Board of Zoning Adjustment Staff Report

May 4, 2015

Case No:	15Variance1014
Project Name:	Springdale Automotive - Eastwood
Location:	16119 Eastwood Cut Off Road
Owner(s):	Kurt & Karen Shelton
Applicant:	Paul Lichtefeld, Litchefeld Inc.
Representative:	Mark Madison, Milestone Design Group Inc.
Project Area/Size:	0.466 acres
Jurisdiction:	Louisville Metro
Council District:	19- Julie Denton
Case Manager:	Sherie' Long, Landscape Architect

Attachment 4 – New (Revised) Building Elevations

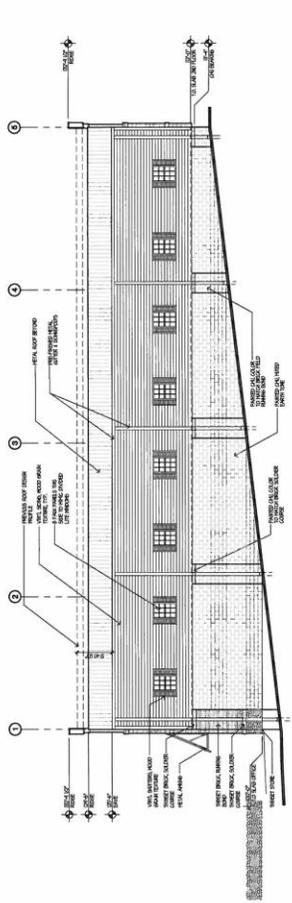
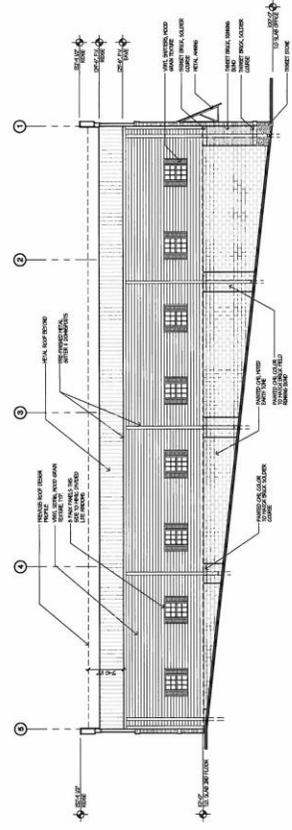
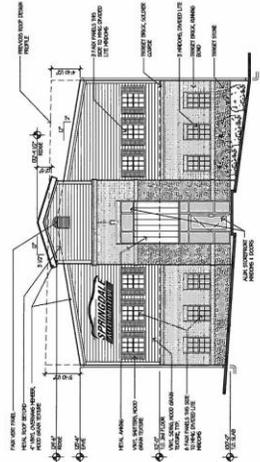
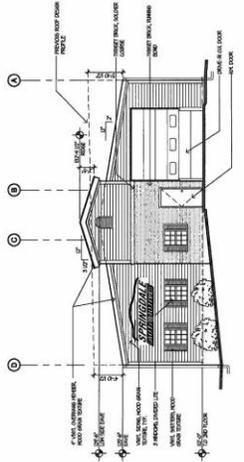
- d) locating the 48 feet wide by 102 feet long by **30 feet high** proposed new building approximately 148 feet from front yard setback will position it **behind and above the existing Eastwood Stove Shoppe** whose roof apex is approximately **only 23 feet high**.

- 4) The exterior of the proposed building needs clarification regarding the building material to be used (per Eastwood Neighborhood Plan).
- 5) If existing residence at rear of property is removed, what will replace it?
